East Park Energy Solar Project

DCO Application 010141

Submission by Phil Wayles on the Applicant's A1/B645 Junction Technical Note

Submission by Phil Wayles on the Applicant's Updated Outline Construction Traffic Management Plan (oTCMP)

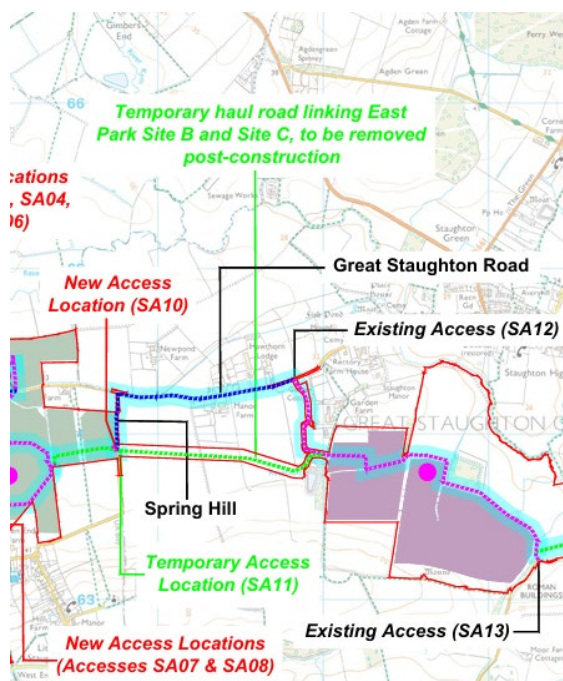
Para 5.1.11 states "*Site B also has a number of site access junctions which require construction traffic to use short sections of the public highway along Great Staughton Road (SA03, SA04, SA05, SA06) and Green End (SA09).*" Also with reference to Para 5.2.1 and 5.2.2, the Applicant's traffic-flow diagrams appear to assign only minimal construction vehicle movements to the SA03–SA06 Great Staughton Road accesses and SA09 at Green End, despite those accesses serving substantial areas of Site B proposed for solar panel development and two of the satellite compounds. The Indicative Site Access Drawings in Appendix D also include swept path tracking diagrams for these accesses. The application does not transparently explain how the

site areas accessed by SA03, SA04, SA06 and SA09 can be constructed with such limited access movements especially as road widening is required at some locations. This creates uncertainty as to whether the traffic assessment materially understates localised construction activity on Great Staughton Road and Green End Road. The satellite compound near Green End should be accessed by an internal haul road, rather than by public highway and site access SA09. This emphasises the oCTMP does not explicitly and clearly set out which existing roads will be used by construction traffic, nor does not show comprehensive details for as requested by the Local highways Authorities and several IPs. A Construction Traffic Permitted Routes / Restricted routes must be prepared for the whole area bounded by the A1, A14, Bedford to the south and B660 / Swineshead Road to the west.
